Service Bulletin

Bulletin No.: 19-NA-103

Subject: Intermittent Click Noise at Front of Vehicle, ABS, Traction Control System (TCS)/
Stabilitrak Lamps May Illuminate Intermittently and/or Deactivate for Ignition Cycle

Brand:	Model:	Model Year:		VIN:		Engine	Transmission:
		from	to	from	to	Engine:	Transmission.
Chevrolet	Volt	2016	2019

531752

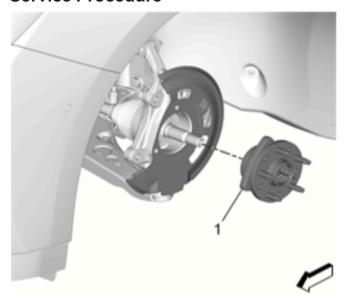
1. Remove the front wheel bearing and hub assembly (1) from the vehicle, on the affected side. Refer to Front Wheel Bearing and Hub Replacement in SI.

Note: In cases where the condition is verified on both sides of the vehicle, remove the anti-click washer from BOTH sides.

5317528

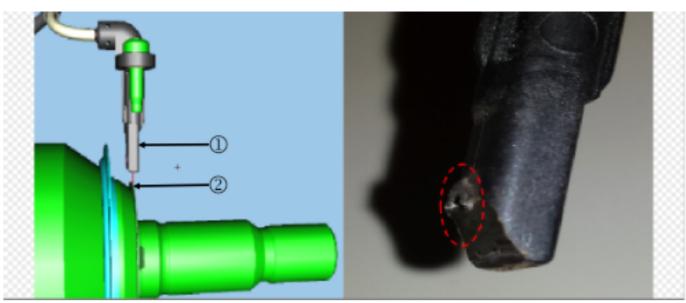
- 2. Remove the anti-click washer (1) from the outboard joint of the half shaft (2) and discard.
- 3. If affected, repeat steps #1 and #2 on the opposite side.

Important: DO NOT install any anti-click washer.

5317526

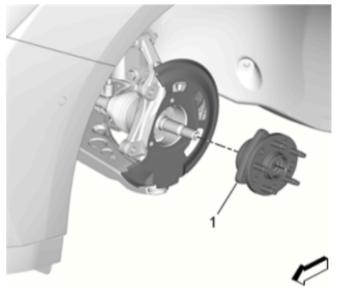
5. Replace any damaged front WSS (2). Refer to Front Wheel Speed Sensor Replacement in SI.

Reinstall the front wheel bearing and hub assembly (1). Refer to Front Wheel Bearing and Hub Replacement in SI.
